**RECONSTRUCTION OF ENCINA AVENUE
FROM MIDDLEFIELD ROAD TO END**

**COUNTY PROJECT NO. RW703
PROJECT FILE NO. E5044000**

ADDENDUM NO. 1

B JUNCTION BOX INFILTRATION GALLERY 3 STA 'E' 26+40.31, 1.50' LT NOT TO SCALE

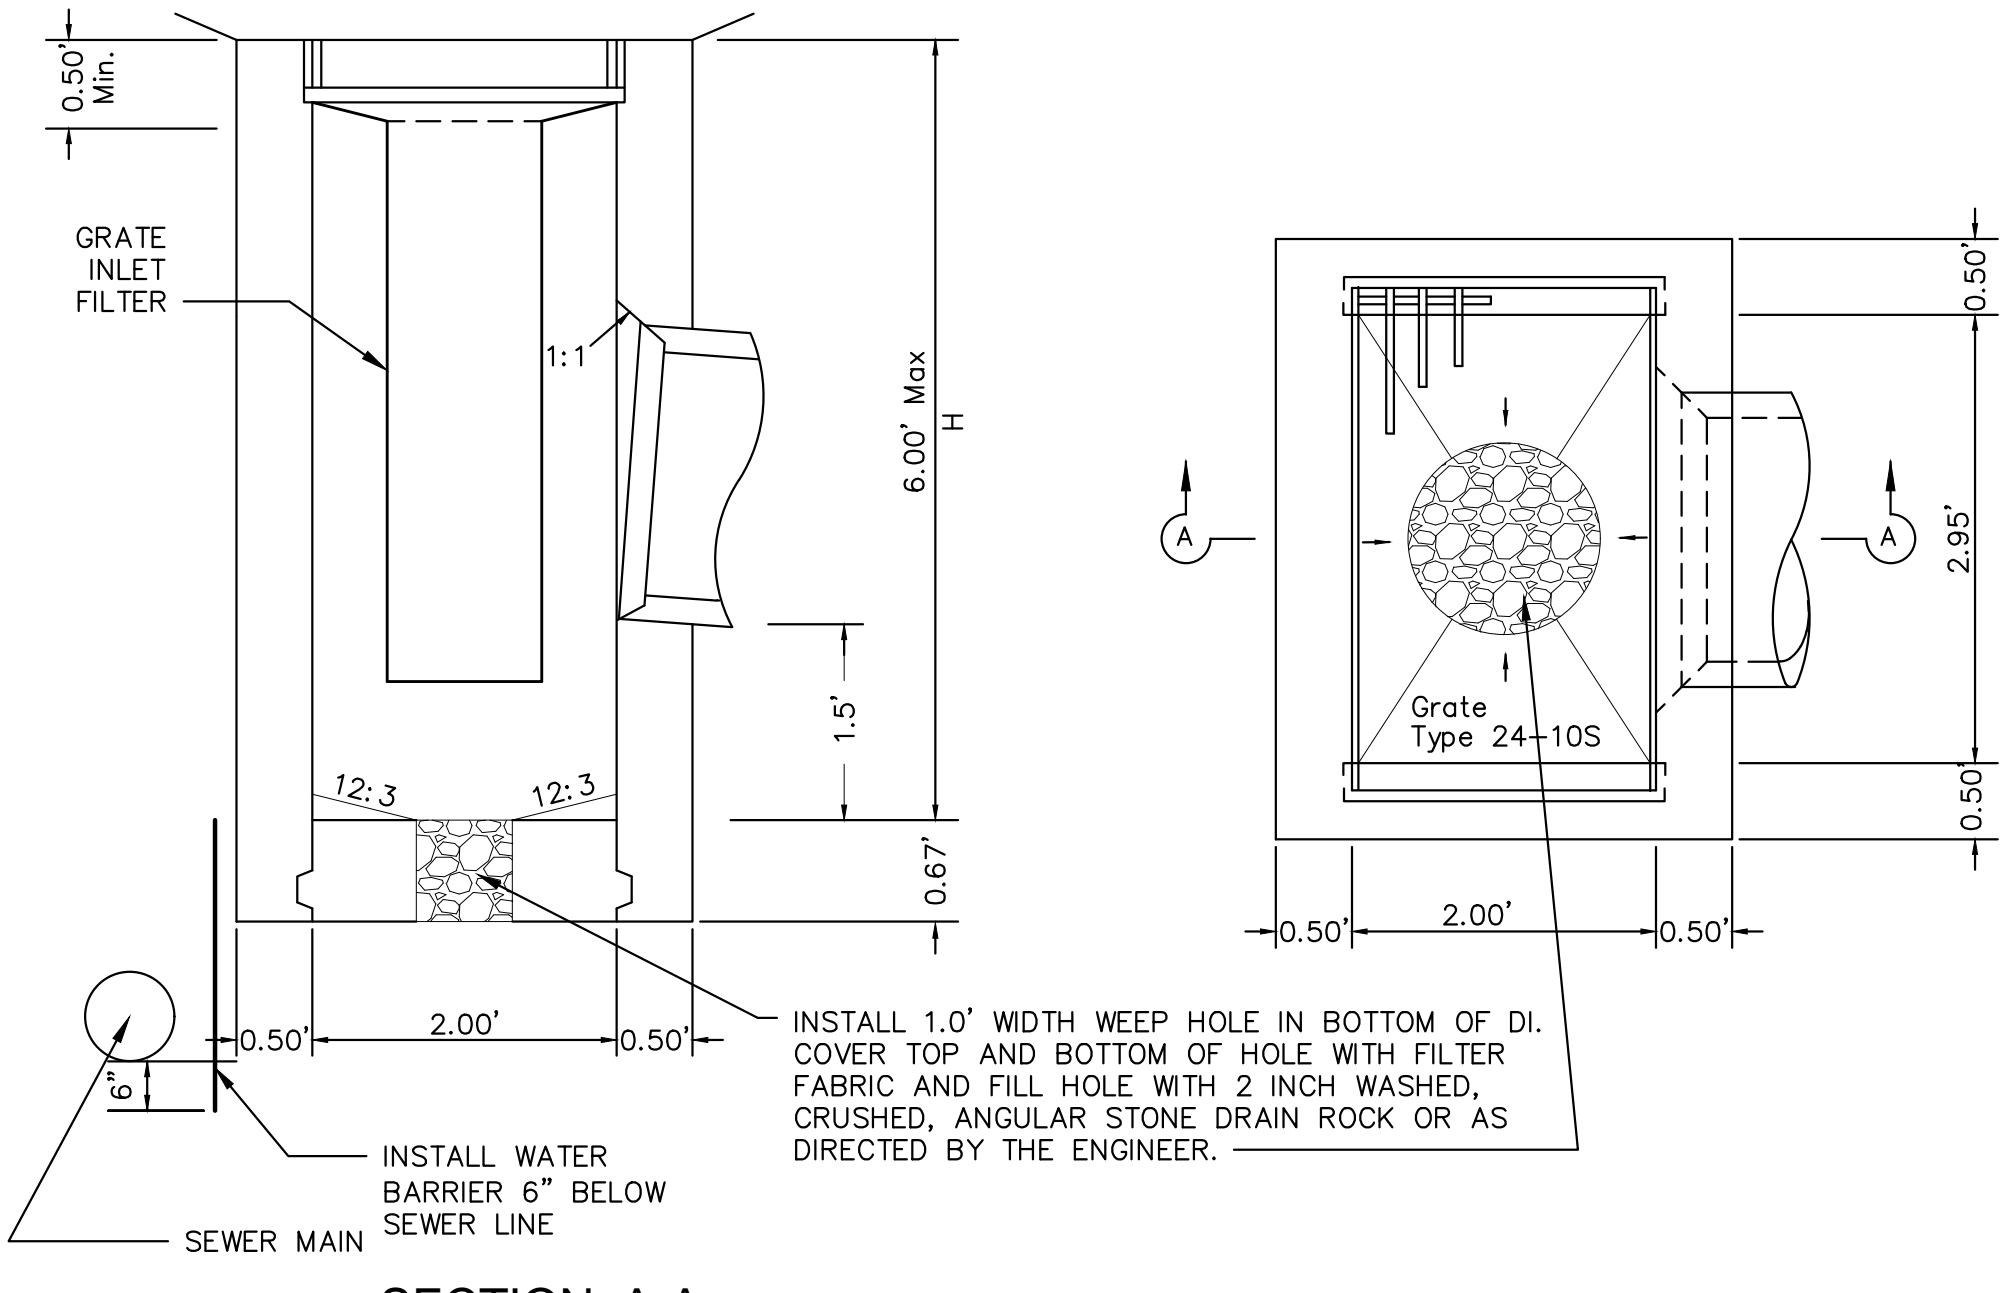
1) LENGTH, ELEVATIONS AND LOCATION OF INFILTRATION GALLERY, CATCH BASINS, STORM DRAIN MANHOLES AND STORM CHAMBERS

1) LENGTH, ELEVATIONS AND LOCATION OF INFILTRATION GALLERY, CATCH BASINS, STORM DRAIN MANHOLES AND STORM CHAMBERS
